RE: MOUNT PLEASANT OPTIMISATION PROJECT – REQUEST FOR INFORMATION

Further to the Department of Planning, Infrastructure and Environment (DPIE) request for additional information regarding the Mount Pleasant Optimisation Project (the Project) (letter dated 27 August 2021), please find attached MACH Energy's (MACH's) responses enclosed in Attachment A.

Attachment A

DPIE Advice and MACH's Responses

Figure 4a

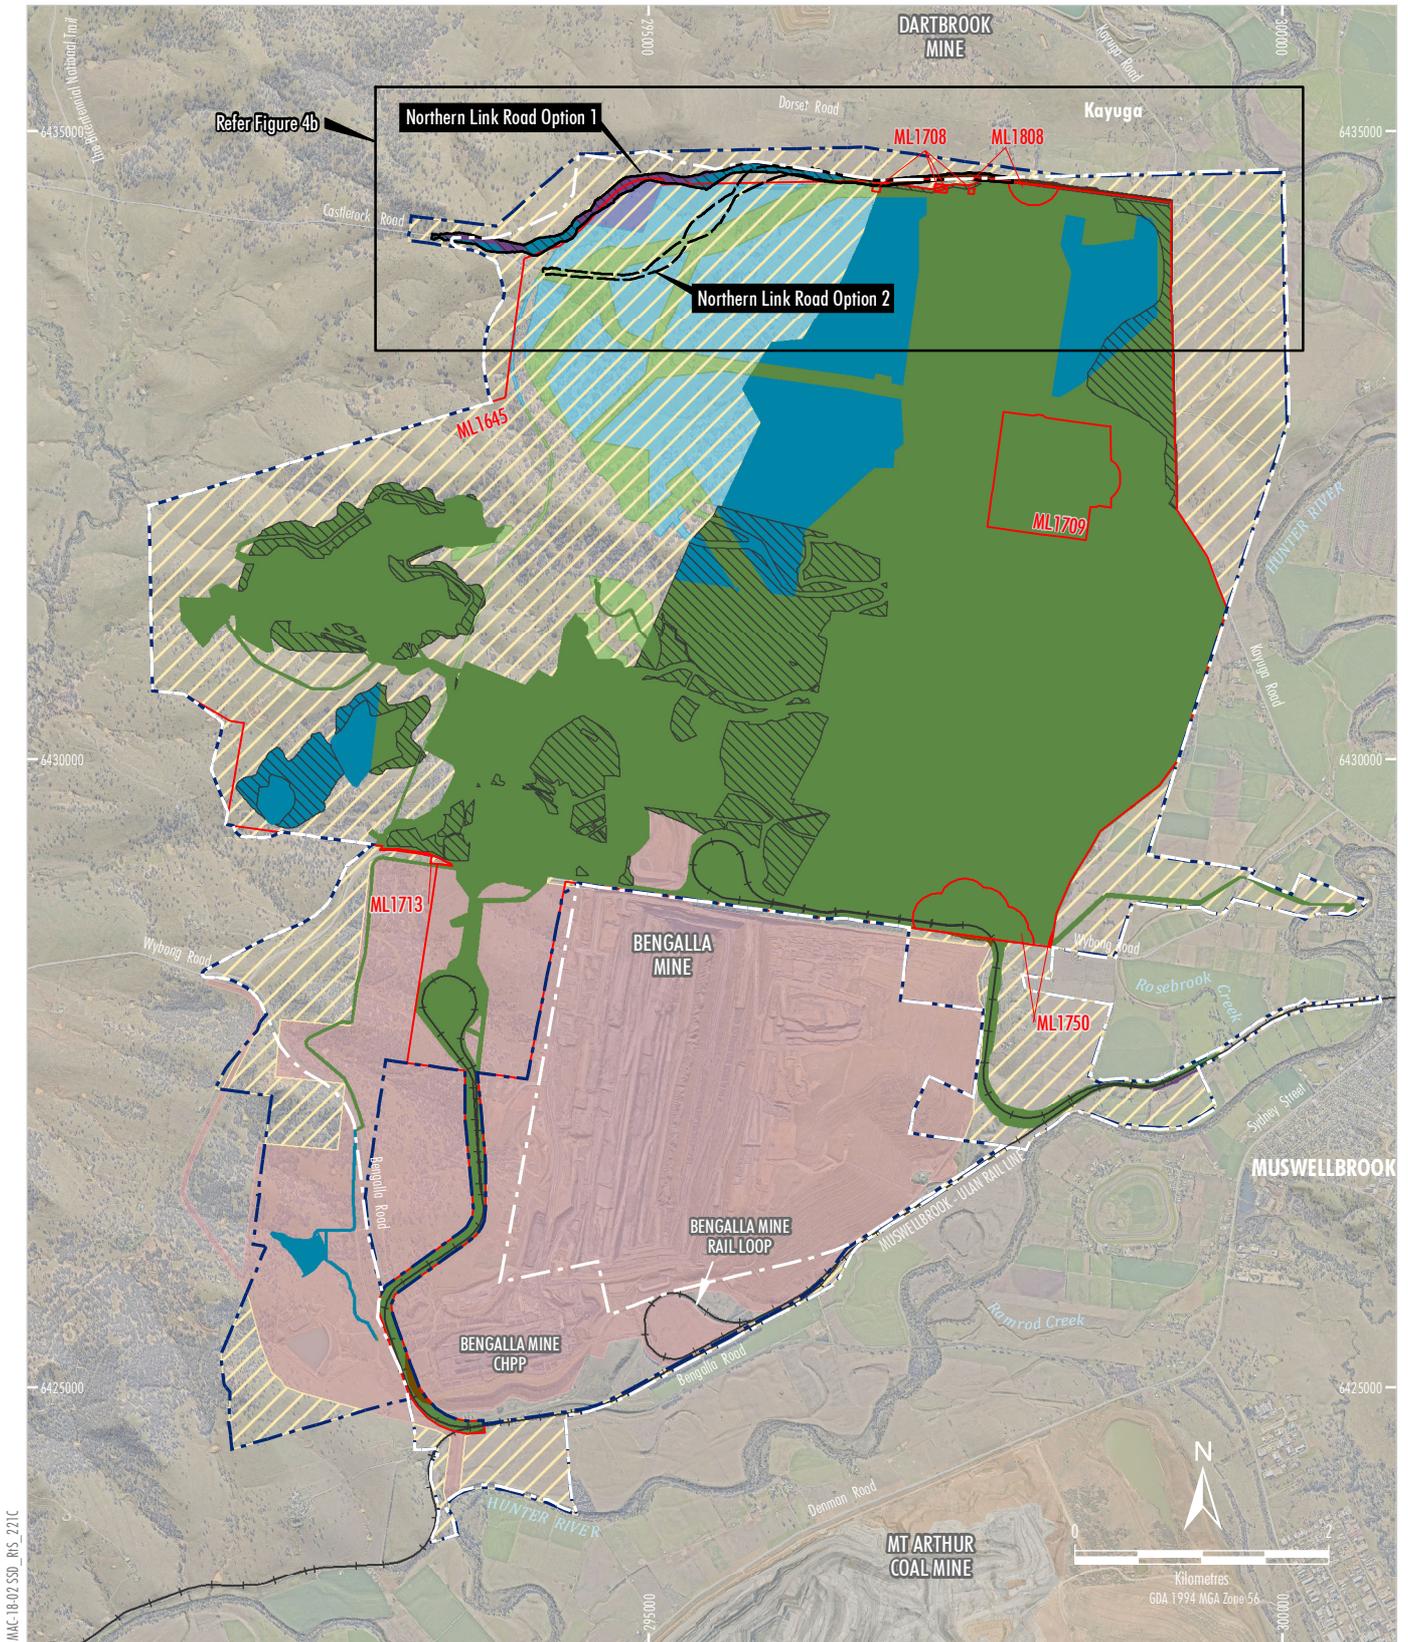
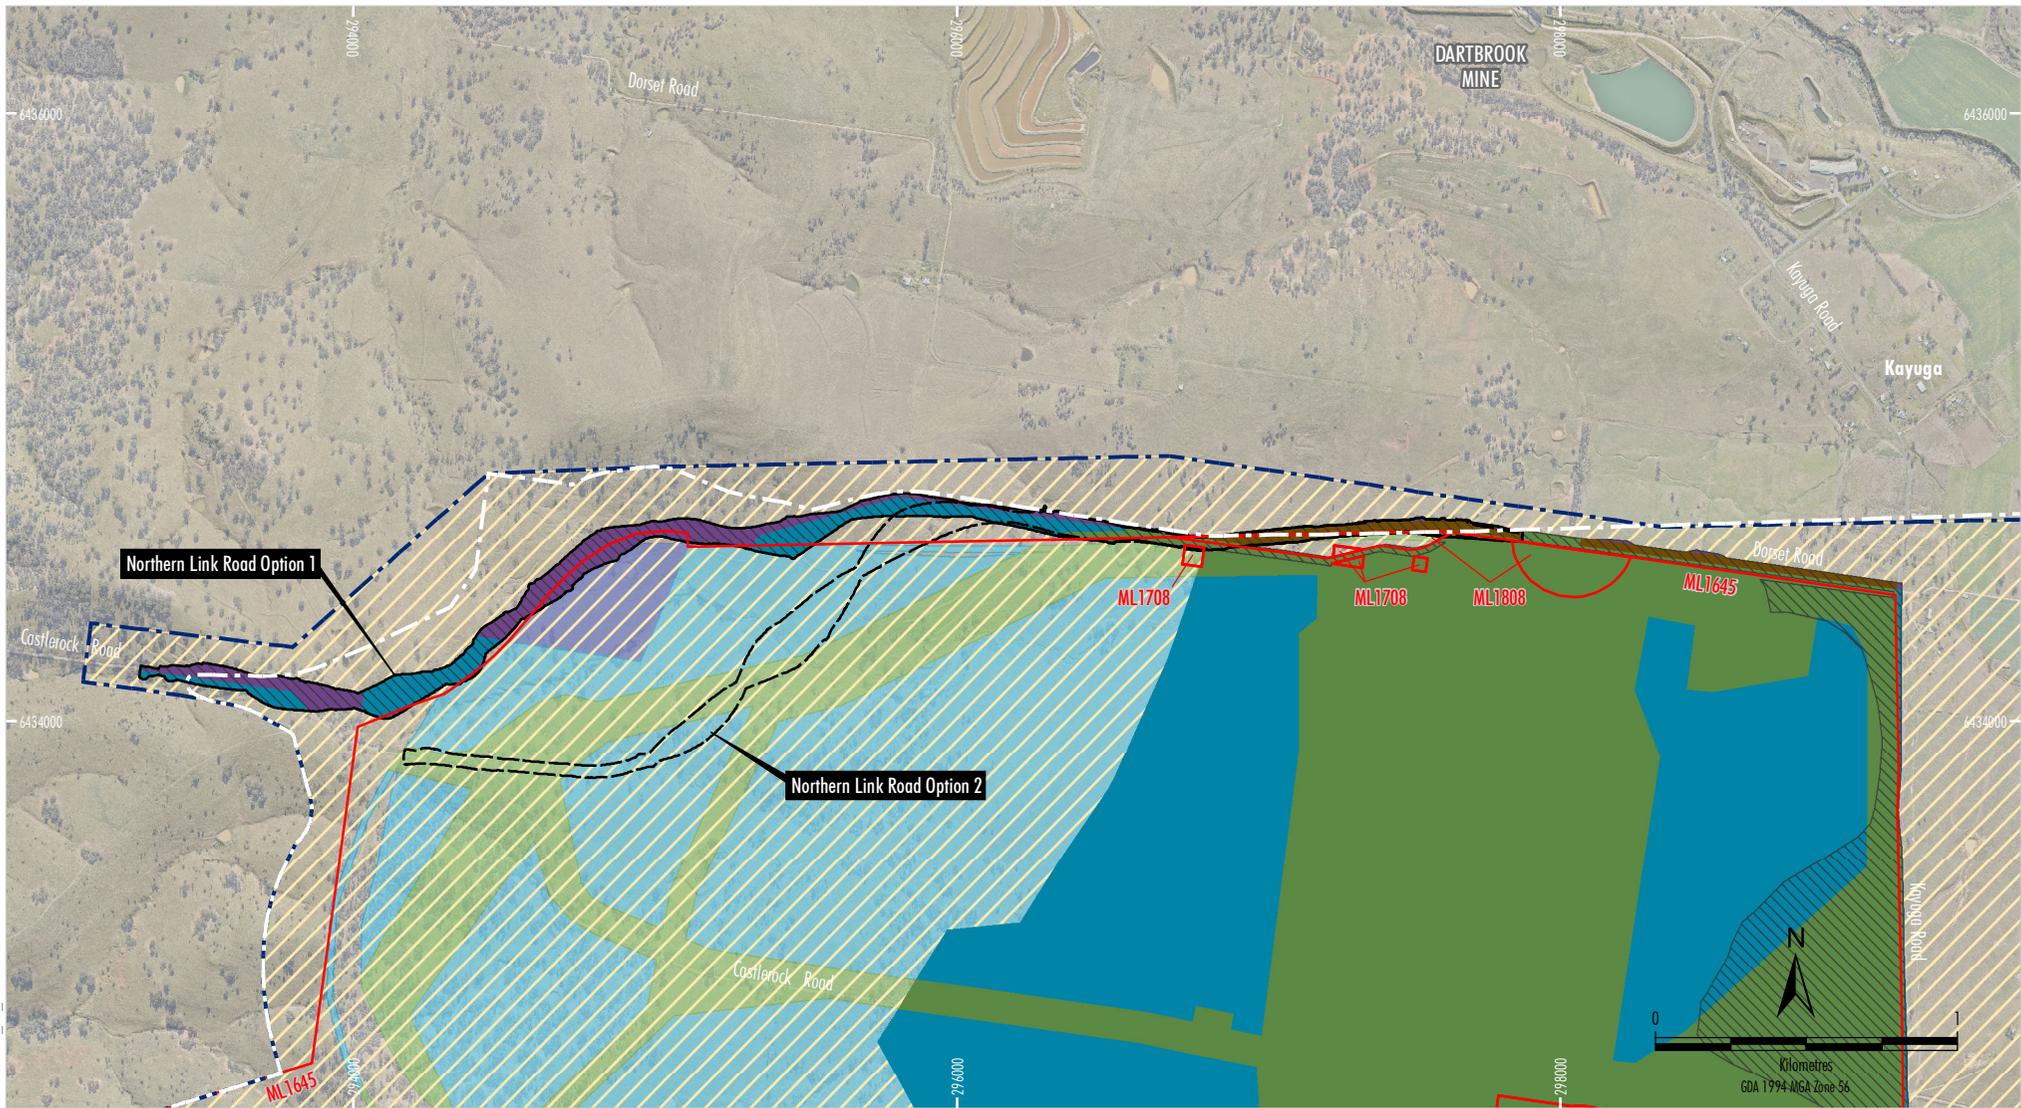
6. *To clarify the location of the separate 'SSD Zones' referred to in the Aboriginal Cultural Heritage Assessment, please provide a detailed figure (or series of figures) showing each of the 15 zones discussed in the Aboriginal Cultural Heritage Assessment (i.e. zones A-A4, A1R-A4R, B-B4 and C). Please include the Development Consent approval boundary (DA 92/97), the mining lease boundaries (ML1645, ML1708, ML1808, ML1709, ML1750, ML1713) and the project disturbance area boundaries (SSD 10418) for each figure.*

Figure 3 shows the area within the Project Development Consent Application Area (SSD 10418) where no evidence of previous Aboriginal heritage survey is available. Figures 4a and 4b show the 15 'SSD Zones' discussed in the ACHA within the Development Consent Application Area (SSD 10418).

Zone C shown on Figures 4a and 4b comprises the Project area outside of the primary Project disturbance footprint and Bengalla Mine's Approved Disturbance Boundary (SSD-5170), where potential minor future Project disturbance may occur subject to detailed engineering design and the ultimately selected alignment of the Northern Link Road. Zone C also includes Zones A1R, A2R, A3R and A4R⁴, which would become Zone C as they would no longer form part of the Mount Pleasant Operation primary disturbance area.

The total unsurveyed area and the zones shown on Figure 3, 4a and 4b reflect the revised Northern Link Road Options 1 and 2 alignments, and incorporate the Aboriginal heritage surveys undertaken as part of the Bengalla Mine Continuation Project (AECOM, 2013)⁵ and the Project ACHA (Appendix G of the Project EIS).

Figure 5

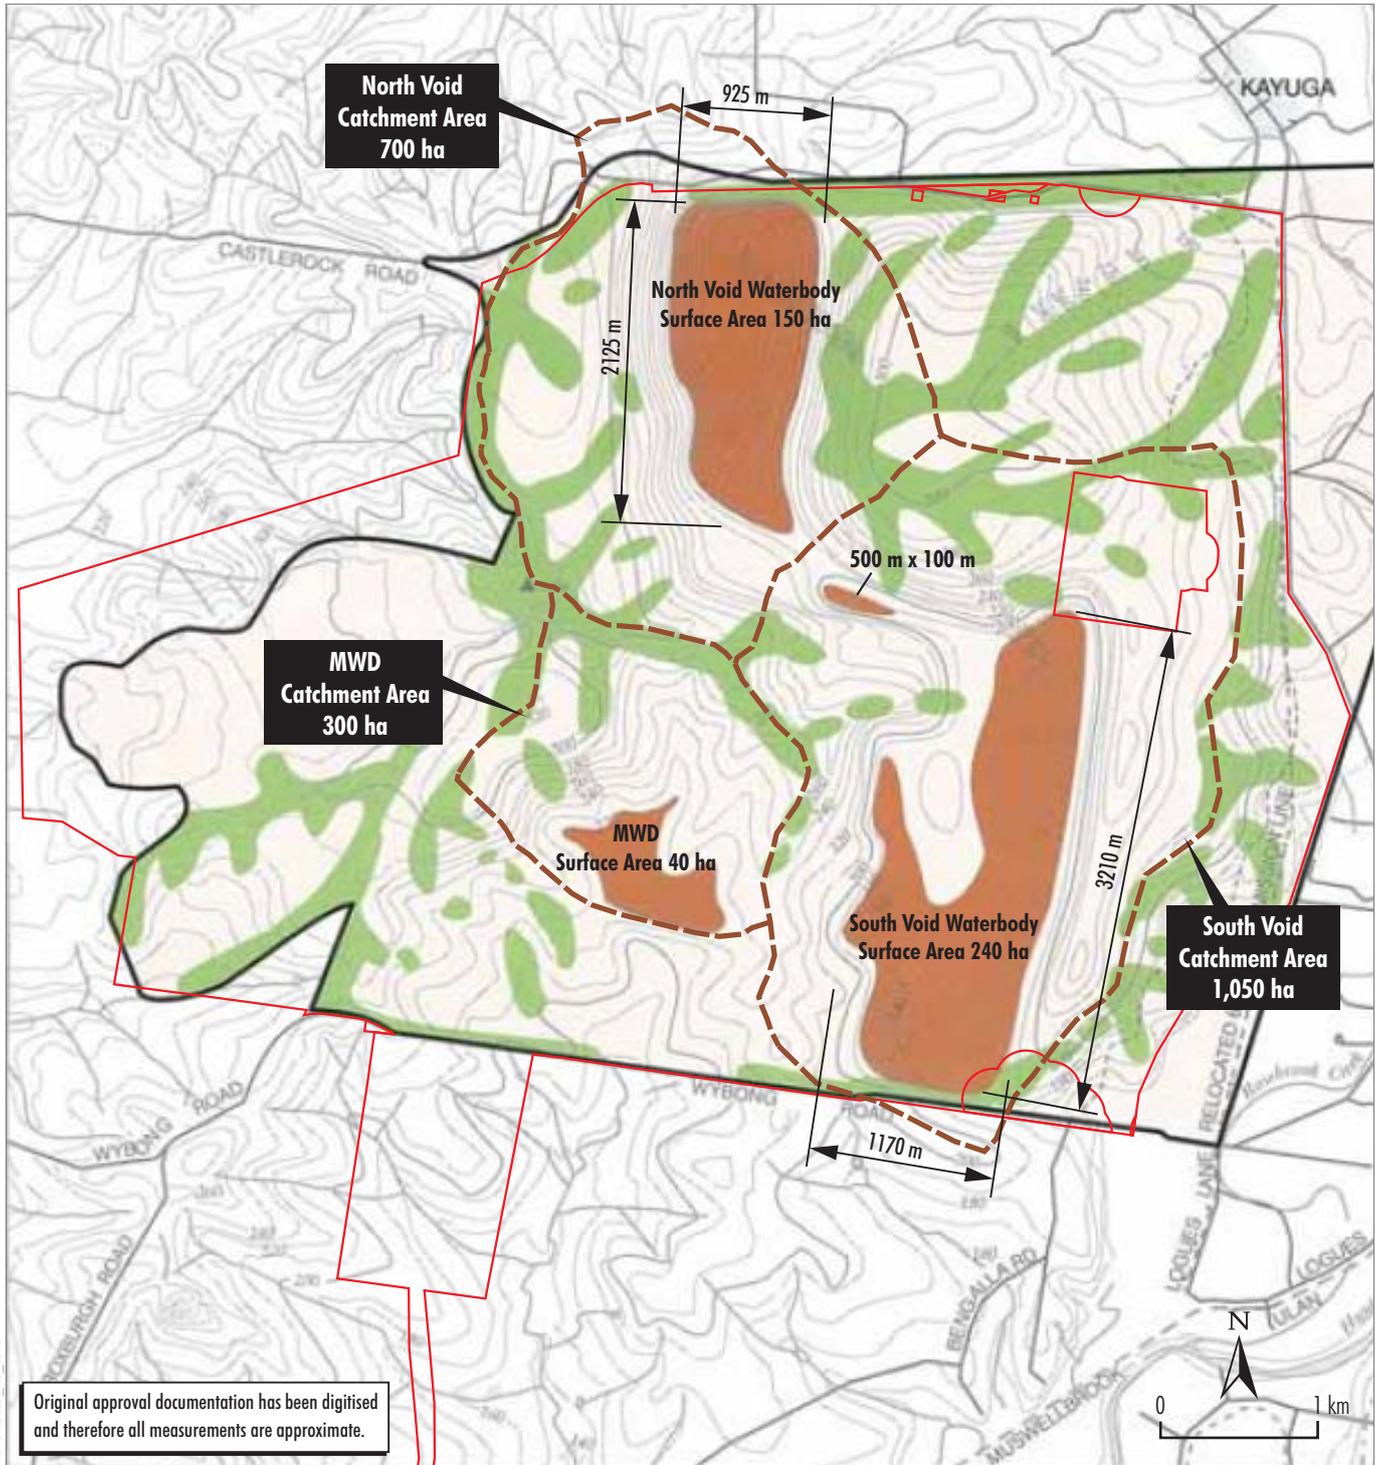
7. *Further analysis and justification is required with respect to the proposed final landform. In particular:*
 - a. *The EIS does not provide sufficient information and justification for the size and depth of the final void. Please clarify the size and depth of the proposed final void and the proposed slope (%) of the internal batters;*
 - b. *Further options analysis should be provided to refine and improve the design of the proposed final void. For example, reducing the total depth, total size, and slope of the internal batters (currently up to 18 degrees); and*
 - c. *Please provide a comparison of the proposed final void for the project relative to the currently approved final voids, including size and depth of the voids and a figure showing their relative locations.*

Figures 5 and 6 illustrate in plan view the approximate area and dimensions of the multiple final voids shown in the landform presented in the original approval documentation for the Mount Pleasant Operation, and the single final void proposed in the Project EIS. Figures 7 and 8 illustrate how these features differ in physical location, depth and extent in both plan and cross-sectional views.
